STAFF REPORT

SUBJECT: Kingstown
H-2022-0045

Annexation of 8.20 acres of land with an R-8 zoning district; and preliminary plat consisting of 28 building lots and 6 common lots on 8.20 acres of land in the R-8 zoning district for Kingstown Subdivision.

C. Landscape Plan (dated: 6/16/2022)

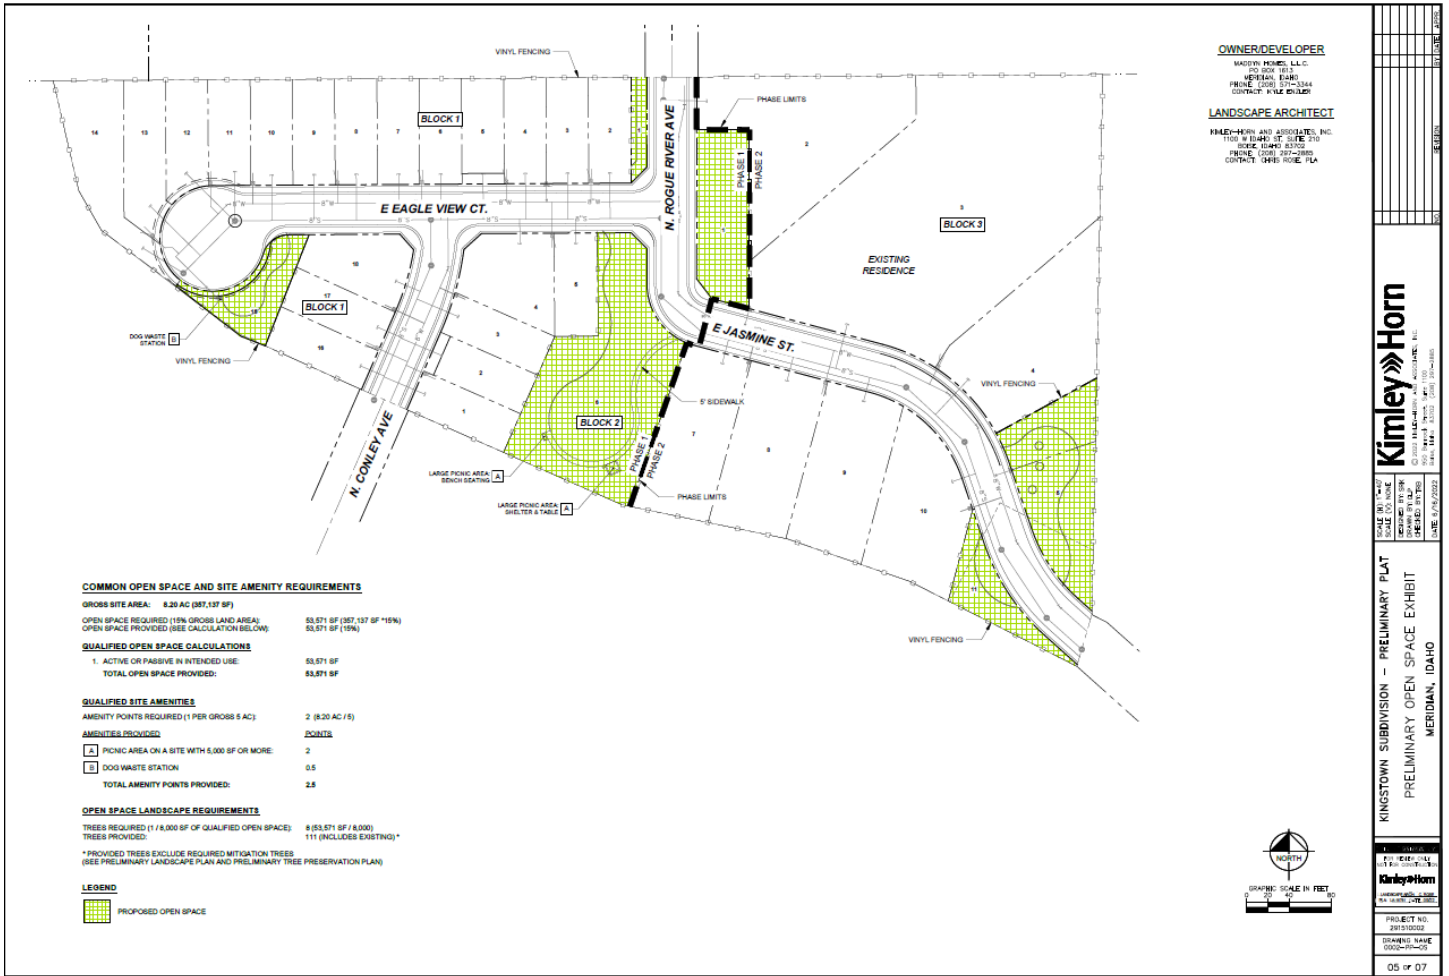
There is a total of 176 existing trees on the site totaling 2,232.5 caliper inches (see existing tree inventory and plan in Section VIII.D). A total of 1,520 caliper inches are proposed to remain with 712.5 caliper inches proposed to be removed. **A total of 391 caliper inches are required for mitigation as set forth in UDC [11-3B-10C.5](#); a total of 170 is provided, which is 221 less than required. Staff recommends one (1) 2-inch caliper tree is provided in the front and back yards of each building lot toward the mitigation requirement, which would leave 109 caliper inches remaining that could be provided in common lots, or Alternative Compliance could be requested to this standard for the remaining mitigation trees (see UDC [11-5B-5](#) for more information).**

Landscaping is required along all pathways per the standards listed in UDC [11-3B-12C](#); the landscape plan should be revised accordingly.

- a. Depict a 10-foot wide multi-use pathway from the existing pathway along N. Conley Ave. at the south boundary to the existing pathway along N. Rogue River Way at the north boundary as required by the Park's Dept. with landscaping along the pathway in accord with the standards listed in UDC 11-3B-12C. *See Park's Department comments & diagram in Section IX.E.*

- b. Provide one (1) 2-inch tree in the front and back yards of all building lots and an additional 109 caliper inches of trees on the site in common areas in accord with the mitigation standards listed

- d. Depict a minimum 20-foot wide common lot along the south side of Lot 1, Block 2 containing a 10-foot wide multi-use pathway connection from Conley Ave. through the common areas on Lot 6, Block 2 and Lot 1, Block 3 to the pathway along the east side of Rogue River Ave. Depict 5-foot wide landscape strips on each side of the pathway planted in accord with the standards listed in UDC [11-3B-12C](#).

E. Open Space Exhibit (dated: 6/16/22)

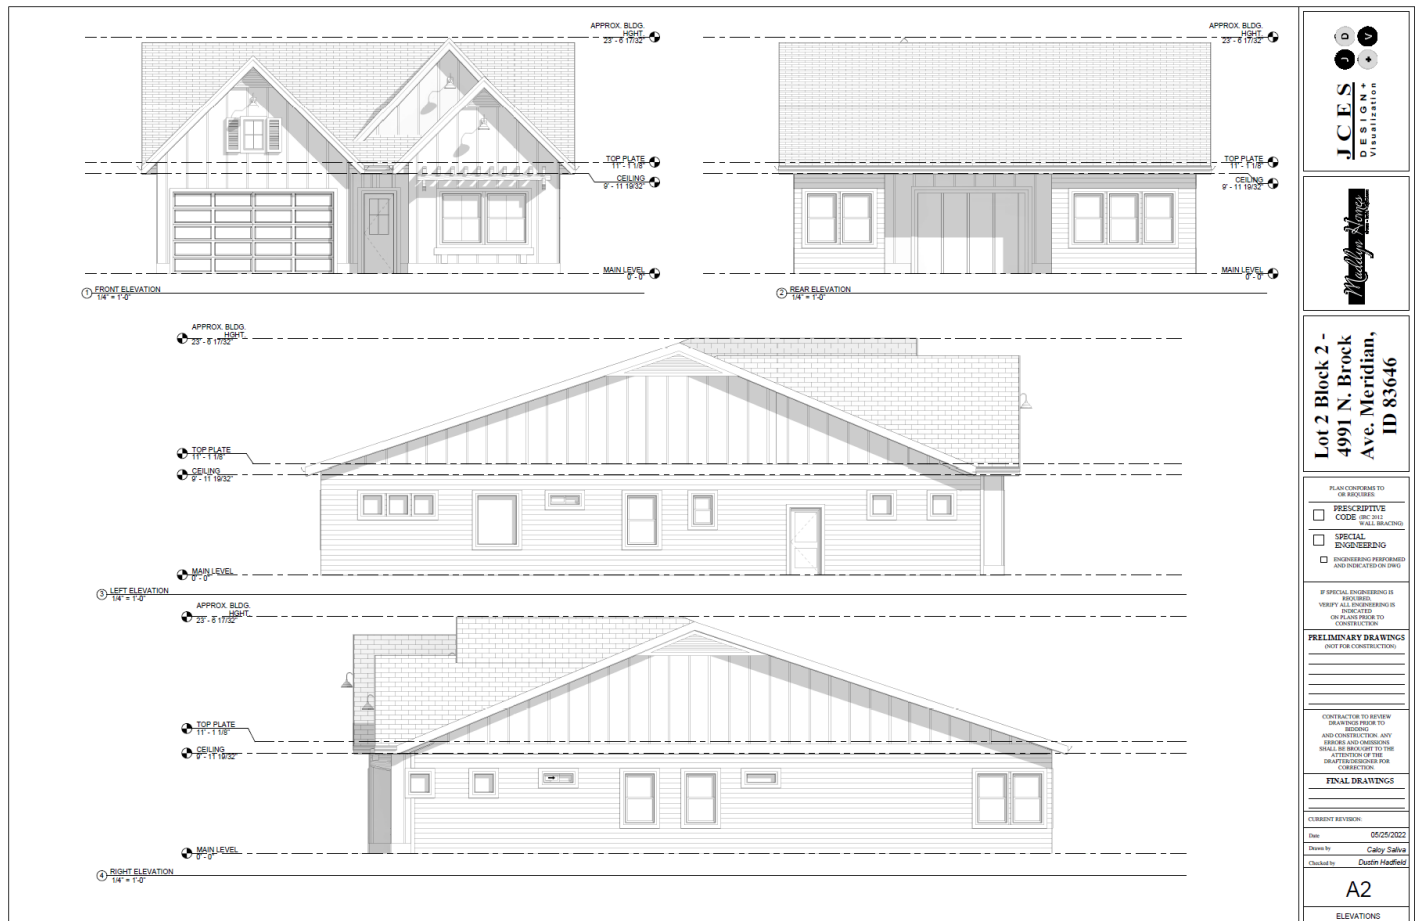
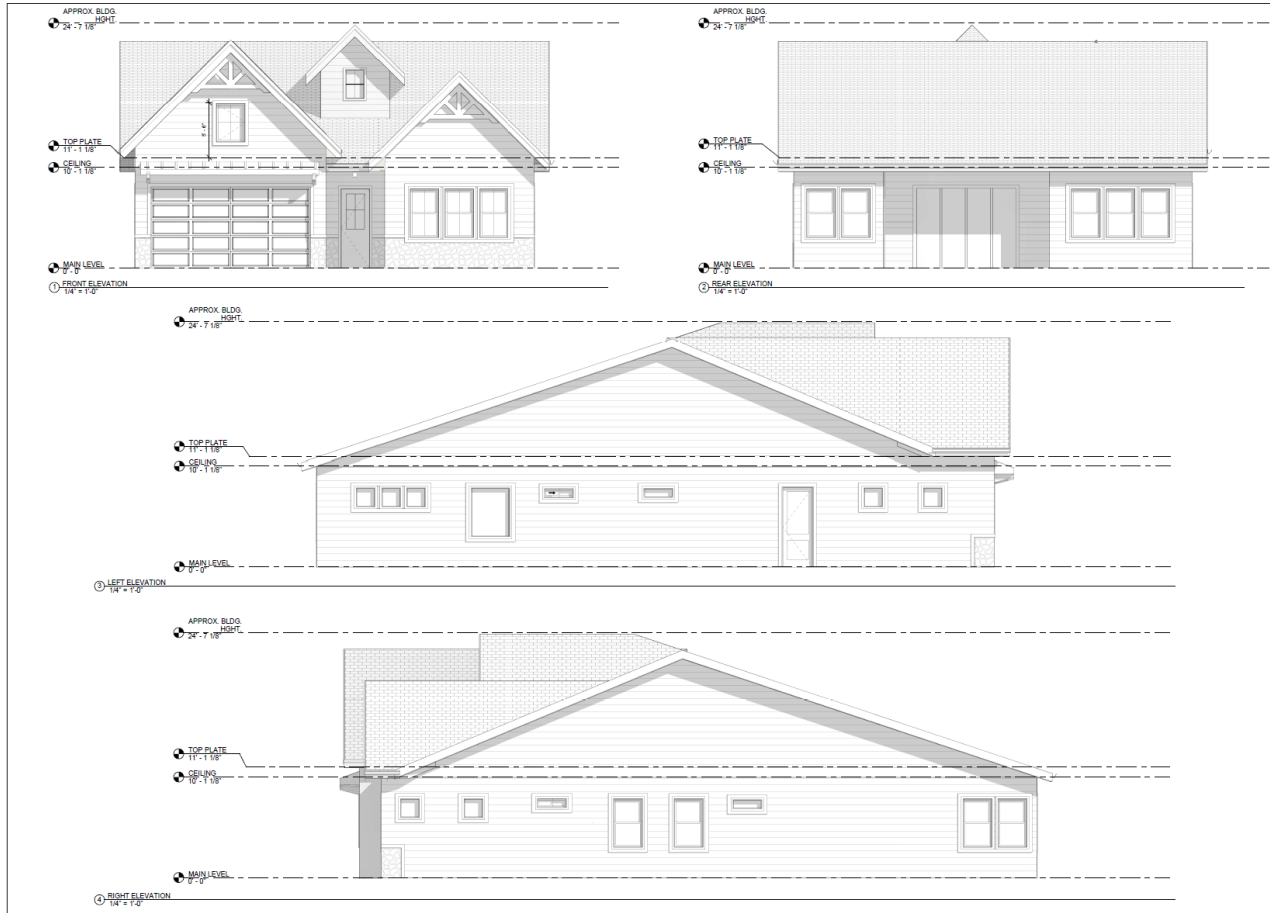
An open space exhibit was submitted that depicts 1.23 acres (15%) common open space for the development (see Section VIII.E). Three (3) of the six (6) common open space lots (i.e. Lot 6, Block 2 and Lots 1 & 5, Block 3) are open grassy areas of at least 5,000 square feet (s.f.) in area and qualify toward the minimum standards. **Lot 1, Block 1 does not qualify; however, if the sidewalk is detached in this lot and an 8-foot wide landscaped parkway is provided, it would qualify per UDC 11-3G-3B.4.**

Although Lot 15, Block 1 and Lot 11, Block 2 meet most of the *quality* standards for open space areas listed in UDC 11-3G-3A, these areas do not demonstrate integration into the development as a priority and appear to be “leftover” areas that aren’t developable as building lots and don’t meet the *qualified* open space standards listed in UDC [11-3G-3B](#). Lot 15, Block 1 could qualify toward the open space requirement if an additional 70 s.f. is added to the lot in accord with UDC 11-3G-3B.1a. Lot 11, Block 2 could qualify if 715 s.f. is added to the common lot in accord with UDC 11-3G-3B.1a; or, a community garden could be added to the existing lot in accord with UDC 11-3G-3B.1; or, a minimum 20’ x 20’ plaza could be added to the existing lot, including hardscape, seating, lighting in accord with UDC 11-3G-3B.1. The plans should be revised as recommended by Staff to meet the minimum qualified open space standards.

- d. Increase the size of Lot 15, Block 1 by 70 square feet to meet the qualified open space standard of 5,000 square feet in UDC 11-3G-3B.1a.
3. The landscape plan submitted with the final plat shall include the following revisions:

- c. Depict a detached sidewalk with an 8-foot wide parkway and landscaping per the standards listed in UDC 11-3B-7C on Lot 1, Block 1 in order for the lot to count toward the minimum qualified open space requirement.

- e. Increase the size of Lot 15, Block 1 by 70 square feet to meet the qualified open space standard of 5,000 square feet in UDC 11-3G-3B.1a.
 - f. Lot 11, Block 2 does not meet the qualified open space standards listed in UDC 11-3G-3B – the plans should be revised to comply through one of the following options: 1) add 715 s.f. to the common lot in accord with UDC 11-3G-3B.1a; or, 2) include a community garden in the common lot; or, 3) include minimum 20' x 20' plaza in the common lot, including hardscape, seating, and lighting in accord with UDC 11-3G-3B.1. *If the lot is enlarged, the plat shall also be amended accordingly.*

F. Conceptual Building Elevations

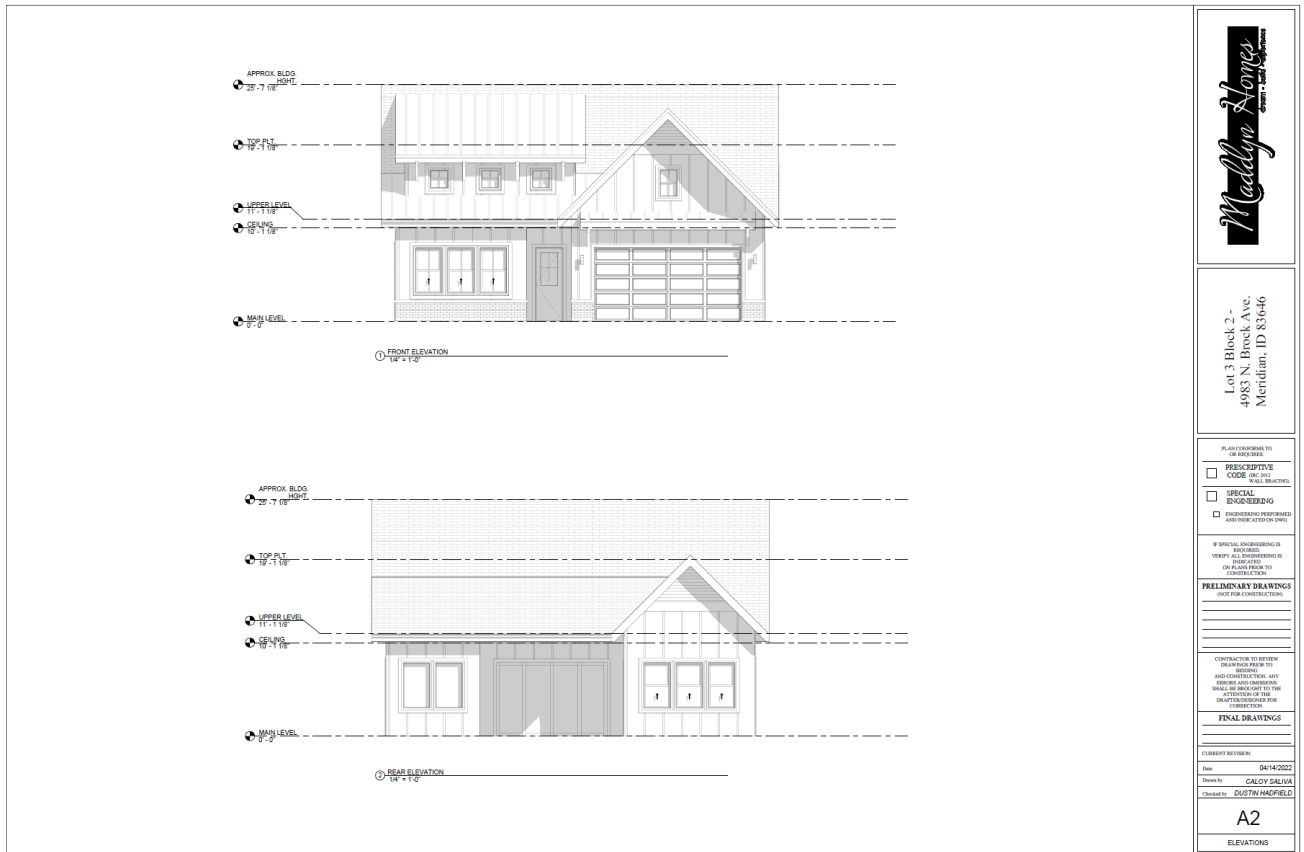
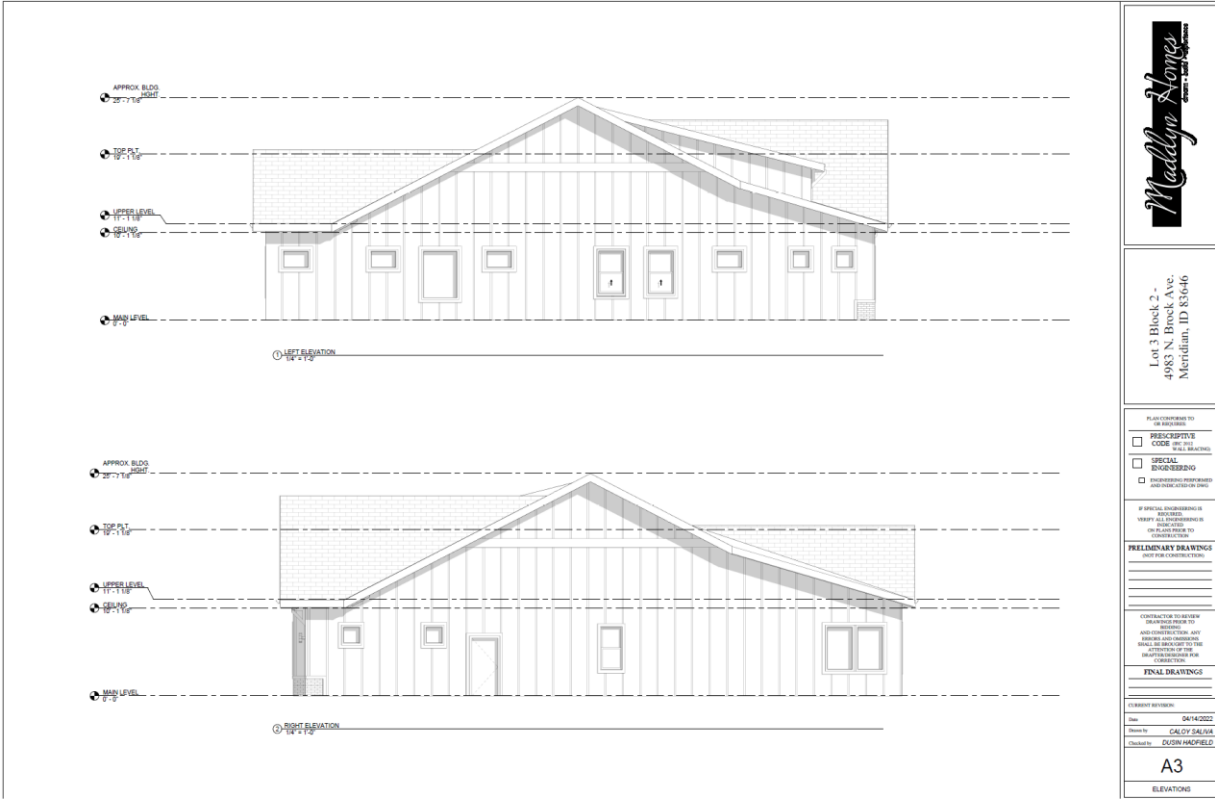
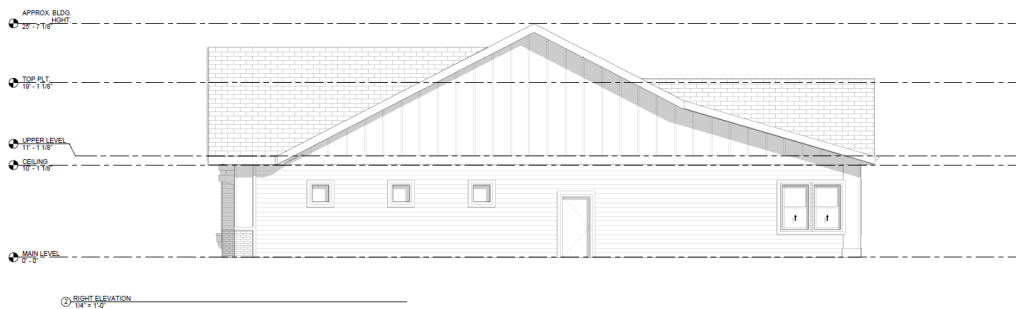
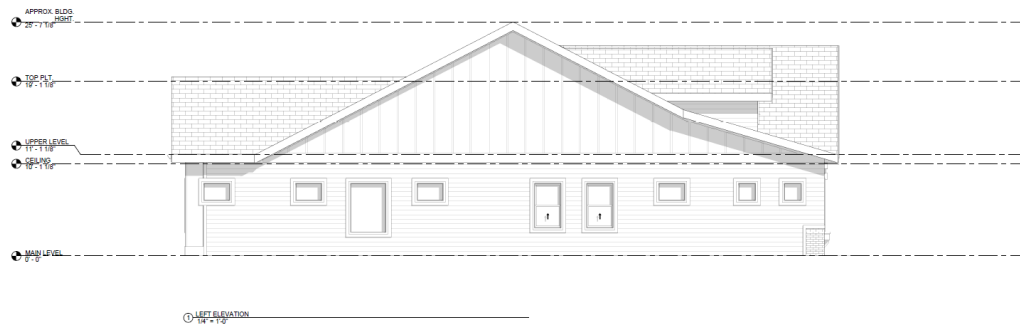
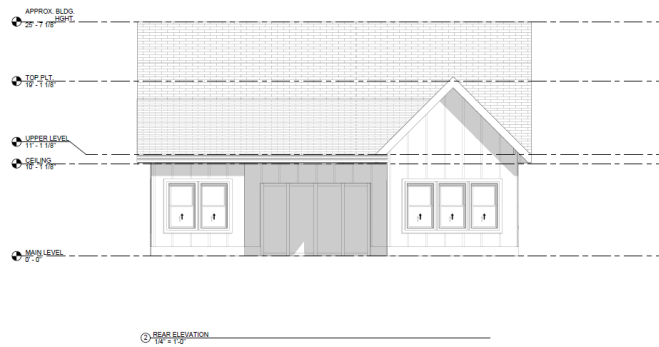
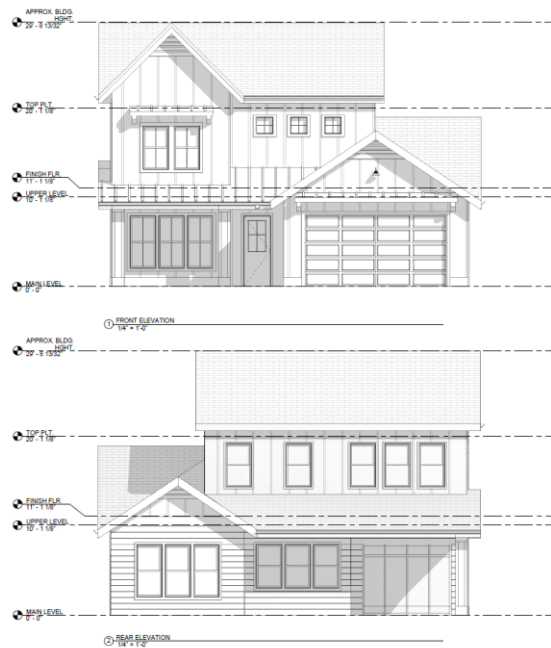
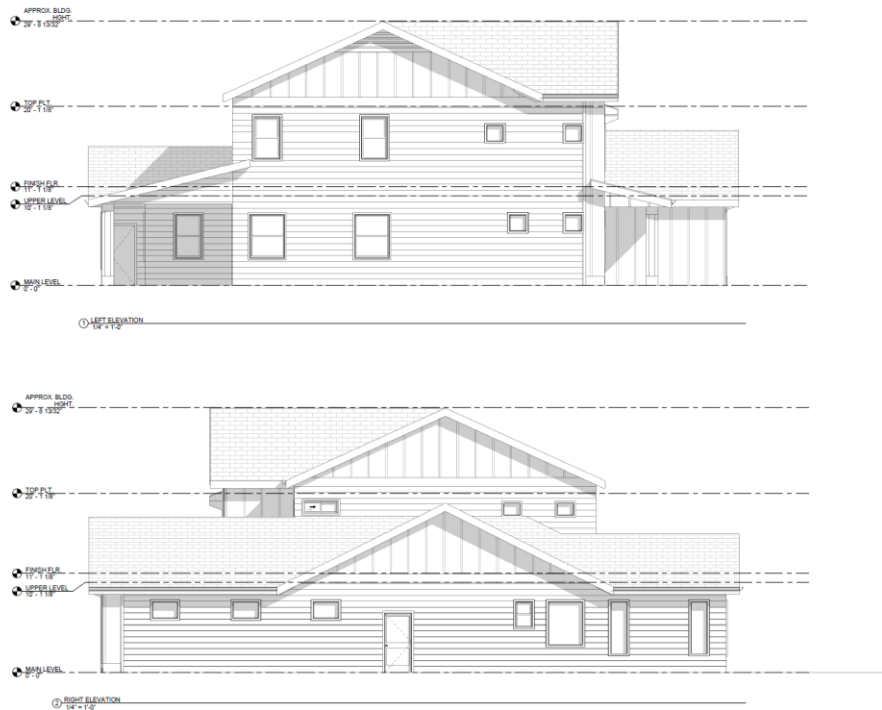
Building Elevations: Five (5) conceptual building elevations were submitted that demonstrate what future homes in this development will look like (see Section VIII.F). A mix of single-story, single-story with a bonus room and 2-story homes are proposed. **All of the floor plans for the proposed elevations depict a width of 40-feet for the homes which will not fit on at least 19 of the proposed lots and meet the required side yard building setbacks of 5 feet on each side – a minimum lot width of 50 feet would be needed in order to accommodate the proposed homes. With 30-foot wide homes, the elevations will be very garage dominated; the narrow lots will also not accomodate very much on-street parking, which is always a concern. Some of these issues should be alleviated with the lot configuration changes recommended by Staff. Prior to the Commission hearing, Staff recommends conceptual elevations are submitted for homes that will fit on all of the proposed lots.**
